Stonegate Elementary School, Mandatory Referral, MR2021035

Summary

Staff recommends transmitting the recommendation of **Denial** to the Montgomery County Public Schools and the Montgomery County Board of Education:

Figure 3: Proposed Site Layout

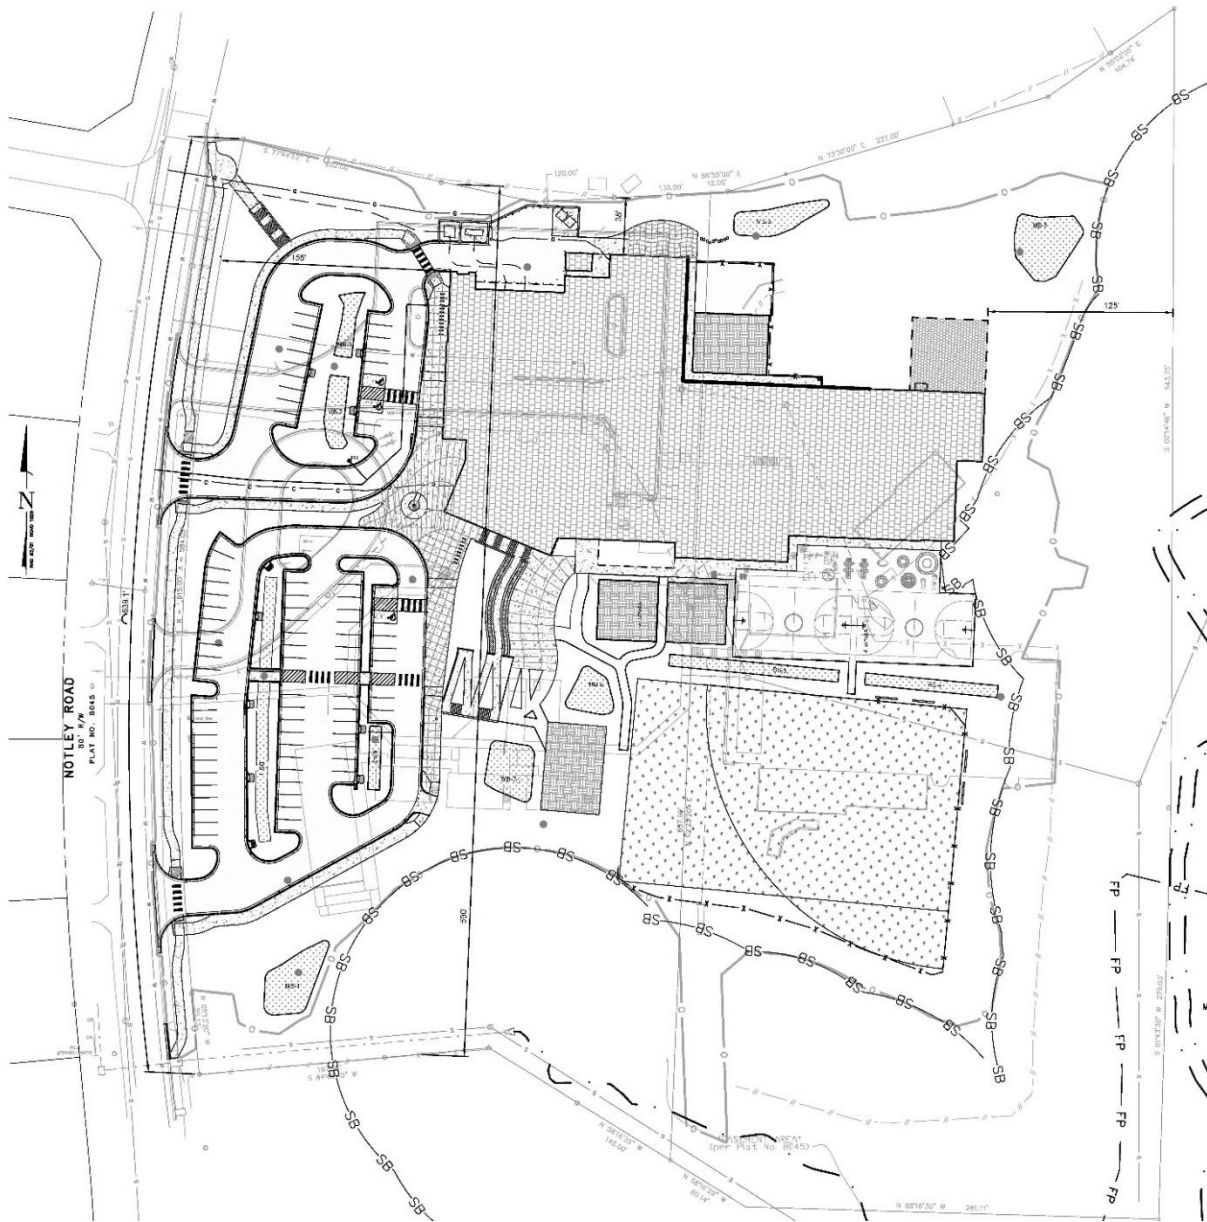
Staff acknowledges that MCPS is dealing with difficult topography at this specific Site and staff appreciated their efforts to incorporate that topography into the building. Staff also appreciates MCPS's attempts to save some construction costs through the recycling of the existing gym's structural columns and beams. However, design elements should be incorporated into the school that provide a greater presence to the public realm of the existing street and maximizes the student, teacher and visitor pedestrian and bike connections to the school. Parking should never be the dominant feature of our public/civic schools. The new building footprint should front the street, and parking should be expanded from its current location at the side of the school with fields behind. A parallel parking lane should be

created along the edge of Notley Road that can be used for bus loading and pick up in the morning and evening, which would allow guest parking and neighborhood parking in off hours. This would dramatically reduce the amount of asphalt on Site, and make the parking useful for the school and neighborhood 24/7.

Applicant's Response: The Applicant did not respond to a request for a meeting to discuss the project prior to the Planning Board hearing and they noted in their ePlans response to staff comments on design issues, "MCPS Division of Construction will plan to address this issue at the Planning Board meeting."

Figure 7: Access Circulation

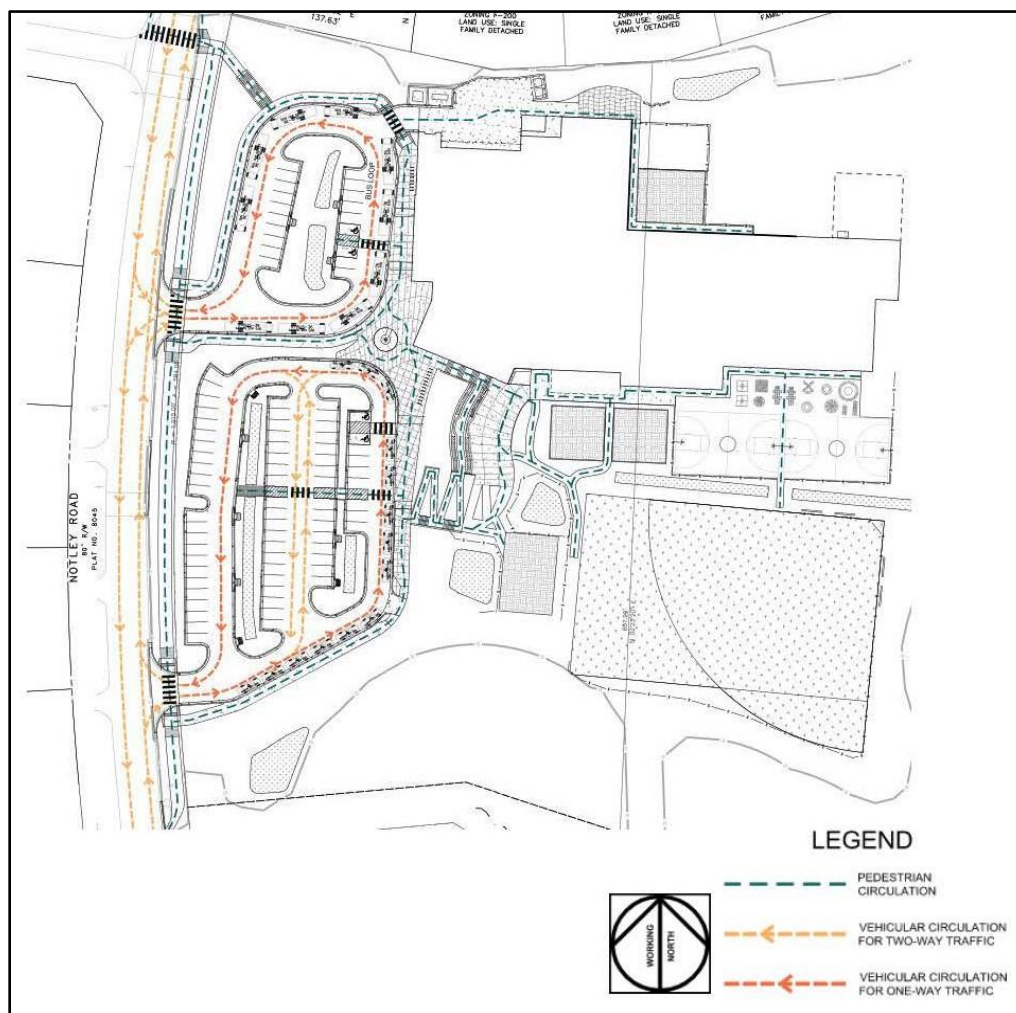
Vehicular access to the site is proposed via two one-way loop driveways off of Notley Road. The bus loop will be located separately on the northwest side of the building, adjacent to the main entrance to the school. The northwestern loop will accommodate busses for pickup and drop off operations and faculty parking. The southwestern loop will accommodate passenger vehicles for additional staff and visitor parking as well as parent pick-up and drop-off operations. The Site is designed with access for motorized vehicles as the priority, while access for walkers and rollers is secondary to access for motorized vehicles. The proposed circulation and parking do not support the public realm and pedestrian safety. The proposed configuration of the school site also does not define the streets or provide a sense of safety and urban design appeal to the public. See Figure 7, Access Circulation.

Internal to the proposed site, pedestrian circulation is adequate and efficient. ADA complaint ramps and 5-foot wide sidewalks will be provided to allow safe access to the internal school amenities, play areas and fields. The prominent location of the parking lots and bus loop provides an auto-centric layout causing an unsafe environment upon entering the proposed school site. Staff recommends that the Applicant considers an alternative design that brings the school closer to the street front to maximize bicycle and pedestrian connections as well as make the school a part of the neighborhood, rather than setback behind pavement, parking lots and bus loops. See Figure 7, Access Circulation.
